UNITED STATES PATENT AND TRADEMARK OFFICE

APPLICATION NO.	FILING DATE	FIRST NAMED INVENTOR	ATTORNEY DOCKET NO.	CONFIRMATION NO.
10/757,017	01/14/2004	Heinrich Kladders	1/1448	3319

Office Action Summary

DETAILED ACTION

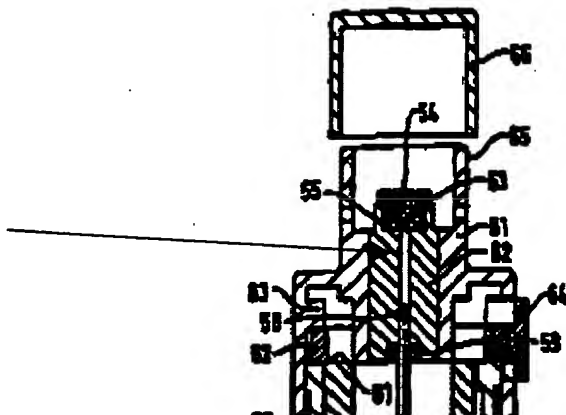
With regard to claim 6, Jaeger discloses the nozzle (54) according to claim 5 wherein the nozzle has at least two nozzle outlets oriented towards one another. "In a nozzle member having at least two nozzle openings at the outlet end, the directions of spray may be inclined relative to one another at an angle from 20 to 160 degrees, preferably at an angle from 60 to 150 degrees" (page 10, first full paragraph). The orientation of the outlets meets the limitation that the nozzle outlets are oriented towards each other.

With regard to claim 7, Jaeger discloses a nozzle system (54) for a device for delivering fluids (First Figure), comprising a nozzle (54) and a nozzle holder (53). Jaeger discloses that "at the nozzle outlet end is at least one circular or non-circular opening less than or equal to 10 micrometers in size (page 9, last paragraph – page 10, end of paragraph). Therefore the size of the opening as it is measured using the micrometer unit of length, has to have the capability of being formed by microtechnology. The examiner has interpreted the claim language that the applicant has used to mean that either a nozzle, or a nozzle and check nut, or a check nut is claimed. Therefore, the examiner selected the first of the three choices to determine the merits of the claim: the nozzle.

With regard to claim 8, Jaeger discloses the nozzle system according to claim 7 wherein the nozzle holder (54) comprises a bore (7) or hole (7), which is constructed as an inner recess which widens out (33) continuously from the nozzle opening.

With regard to claim 10, Jaeger discloses a side of a recess remote from the nozzle opening

the arrow points to the side of the recess, remote to the nozzle opening (54).

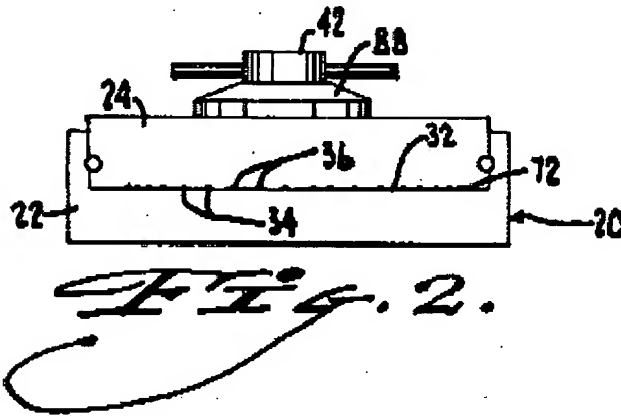
With respect to claim 17, Waldrum teaches wherein the spacings between the elevations and depressions are in the range from 0.1 to 200 microns. "One or both of the nozzle plug and the nozzle body have a plurality of narrow grooves (or elevations and/or depressions on the surface structure). This dimension of 0.001 to 0.015 inch is equivalent to 25 to 400 microns in width and therefore covers the claimed range (Abstract).

With respect to claim 18, the production by microtechnology/nanotechnology is a product-by-process limitation. As shown in Figure 2, the grooves (36) of Waldrum appear to account for at least 20%, more than likely much more, of the corresponding surface.
